The Town of Erie

Memo

To: Heidi Majerik, Erie Land Company LLC
From: Hannah Hippely
Date: February 7, 2019
Re: SK-001023-2018 – Dearmin Sketch Plan No. 2 Application

Figure 1a

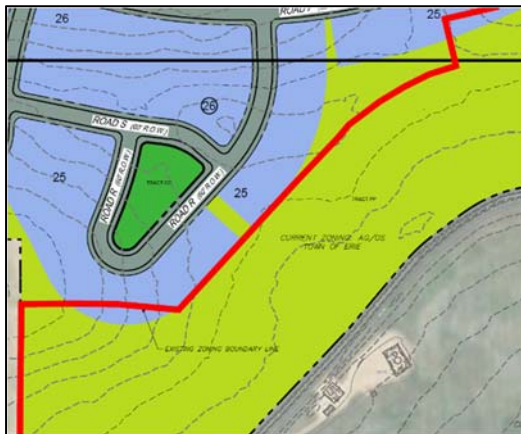
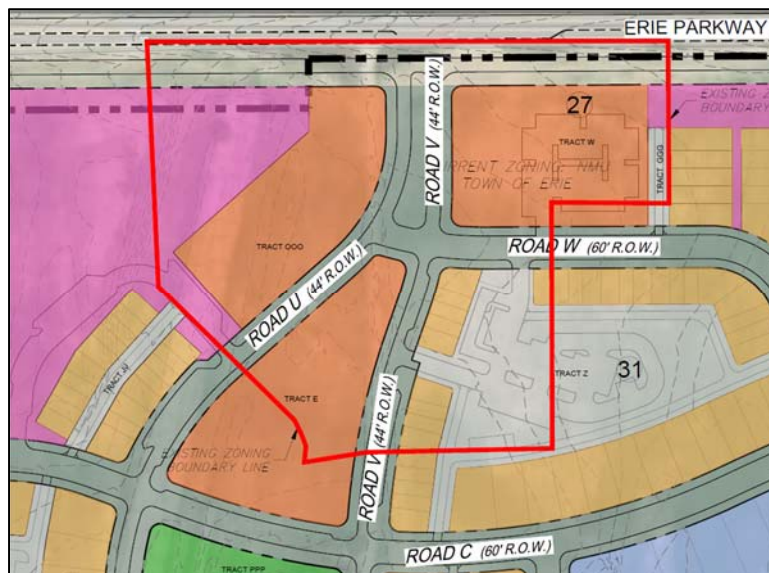
3. The property is currently zoned NMU, LR and AG-OS. The sketch plan proposed would require that the current boundaries be adjusted.
 - a. In Figure 1a and 1b below, the red line is the current boundary between the Low Density Residential (LR) District which is located above the line and Agricultural/Open Space (AG/OS) District located below of the line. In this sketch plan residential lots are proposed within the area zoned AG/OS and these areas would need to be rezoned to permit this.
